Minor Design Change - Configuration Change no AEPS system

Part name/number:	Bristell B23
Product/TCDS number:	Bristell B23 EASA.A.642
Reason for change/repair request	Addition of a configuration of the Bristell B23 without the installation of the AEPS (aircraft emergency parachute system) and related parts. To achieve equal zero weight and cg a dummy mass is installed in the AEPS bay.
Preliminary change / repair description	Parts drawings: new mass ballast dwgs (to compensate mass of missing AEPS system (mass and cg similar)) Assy drawings: new assy drawings with new configuration Placard drawing: new placard drawing with corresponding placards for new configuration AFM: new AFM with updated procedures AMM: new AMM with updated maintenance instructions
Change/repair request by, date:	As requested per design change requests ADxC-DCR-73-013 and -014 Milan Bristela, 09.12.2020

<p>Aircraft Design Certification GmbH Reichensteinstr.48 69151 Neckargemünd</p>		<p>Bristell - B23</p>	<p>Doc-Nr: ADx-C-73-DC-008 Issue: A Date: 29.04.2021</p>
<p>Minor Design Change - Configuration Change no AEPS system</p>

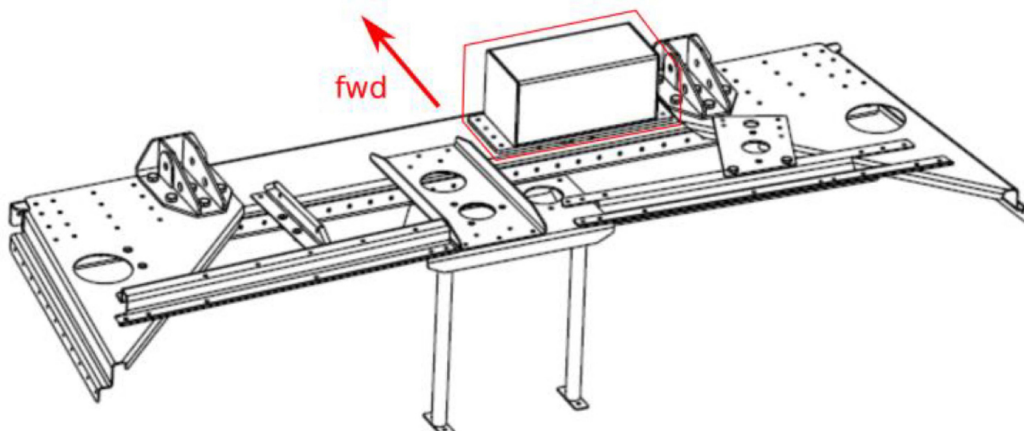
Change of configuration: installation of mass balance instead of the AEPS system as can be seen in the drawing below (marked area) next to the front RHS engine mount bracket and adjacent to the firewall.

The dummy mass consists of a welded steel casing filled with lead to a total mass of 12kg. It is riveted to the structure (front fuselage cross channel) by means of 4,0x12,7mm pop-rivets.

Removed parts (compared to basic configuration) is just one supporting bracket for the AEPS system:

- 53B220115N_B BRS BRACKET 2
